THE DEVELOPMENT AT DALE EVANS AND LAFAYETTE

FINAL ENVIRONMENTAL IMPACT REPORT

2.0 RESPONSE TO COMMENTS

Figure 2: Project Site Plan

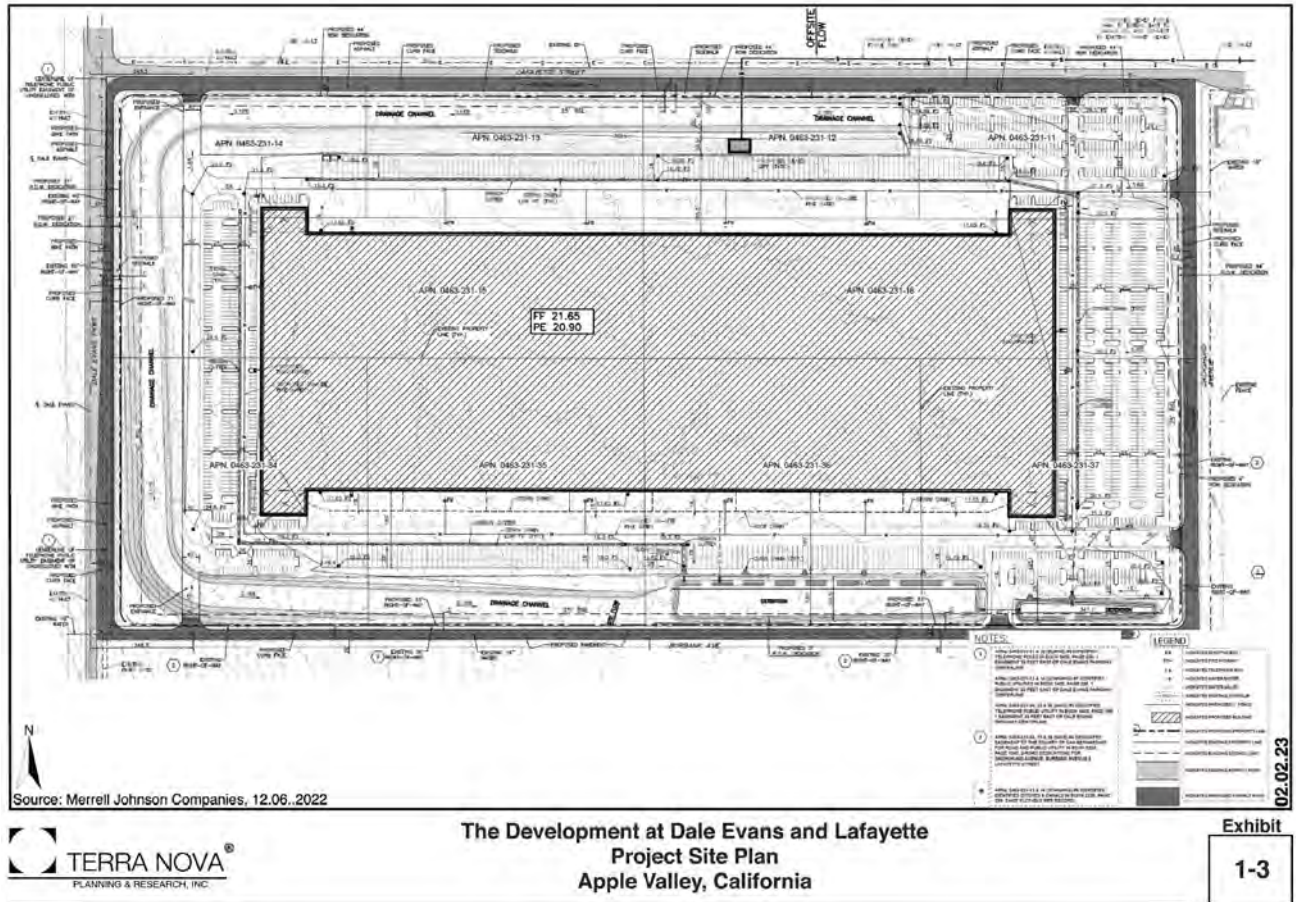
The DEIR concludes that no mitigation is required to prevent impacts from the project on air quality in the area. This conclusion is in conflict with the facts provided within the DEIR.

Figure 4: 40 Mile Radius From Project Site

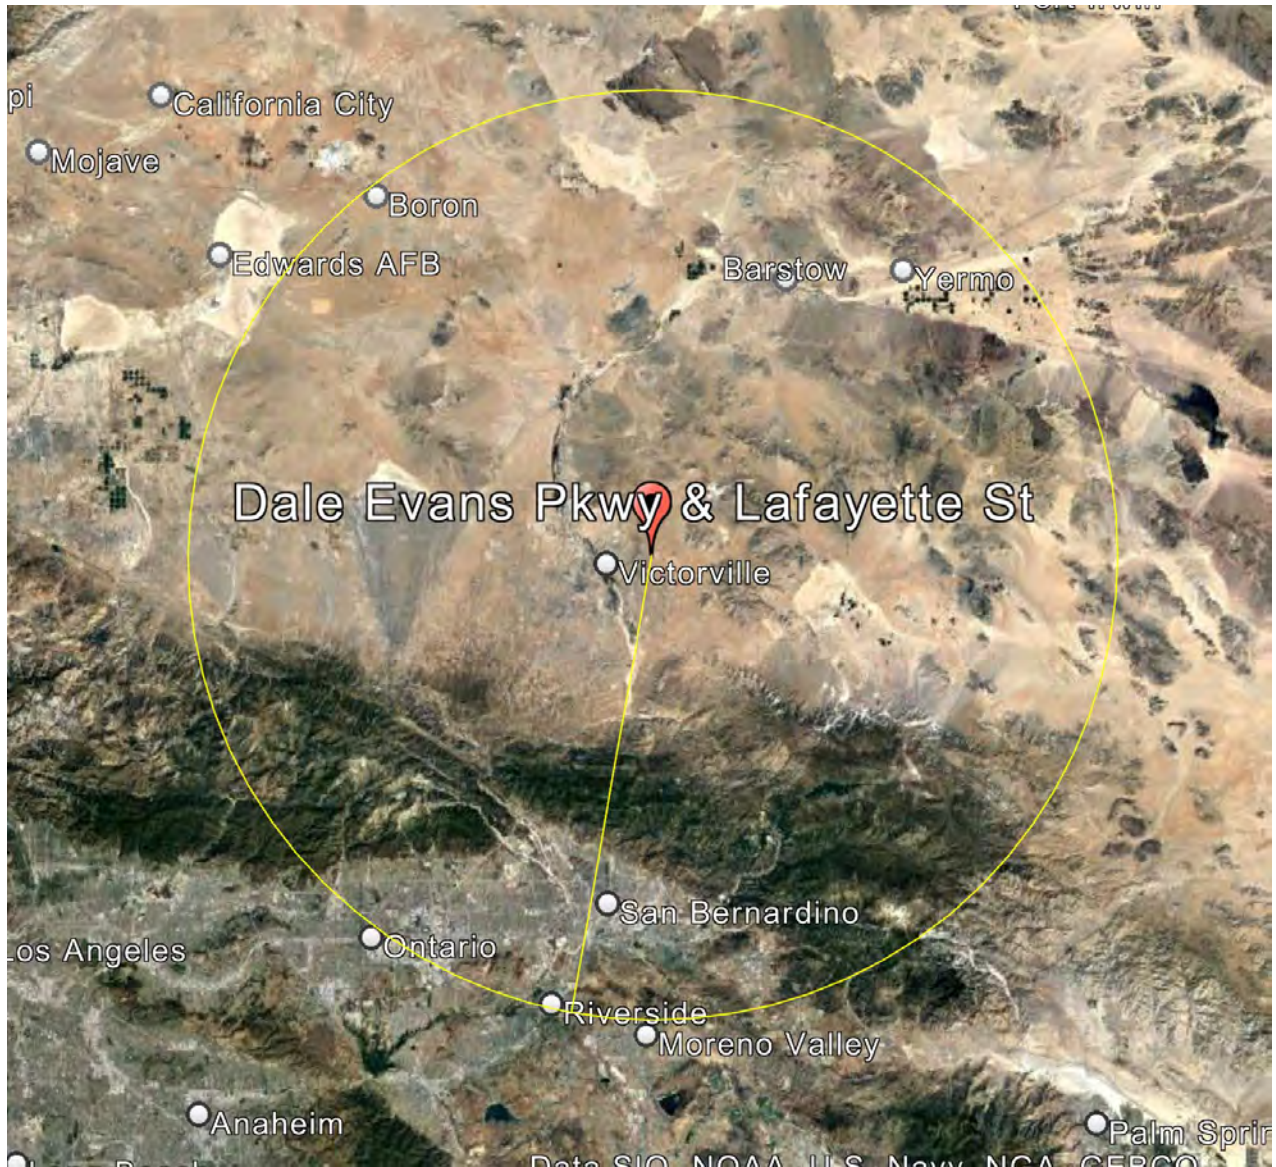
The distance from the Project Site to the Ports of Los Angeles/Long Beach is approximately 80 miles, almost twice the value assumed in the air quality analysis. Using the 80-mile daily truck trip will nearly double the daily emissions of pollutants associated with the Project, increasing the Regional burden and resulting in a potentially significant impact. The Town must address the impact of this issue in a revised DEIR.
